Report: TAB REPORT
Function: Test, Adjust, & Balance
Date: 11/28/2022

11-28 FREDDY'S BETHLEHEM, GA (WINDER)

Project: 11-28 FREDDY'S BETHLEHEM, GA (WINDER)

Issue Name : 3. RTU-1 Throwaway Final Filters Installed

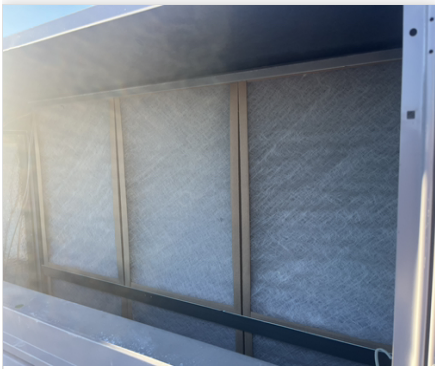
Description : Throwaway construction final filters are installed. Recommend pleated final filters are installed.

Issue Name : 4. Exhaust curb not sealed.

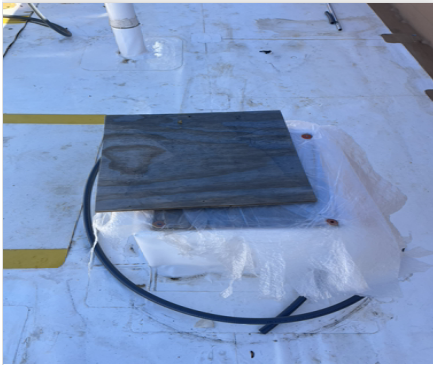
Description : Original plans called for a roof mounted restroom exhaust fan. Curb and ductwork were installed, but fan was not. Ceiling fans installed in restrooms instead. Unsure if roof mounted fan will still be installed. Curb is not sealed. Plywood is unsecured, laying over roof opening. Recommend opening is sealed.
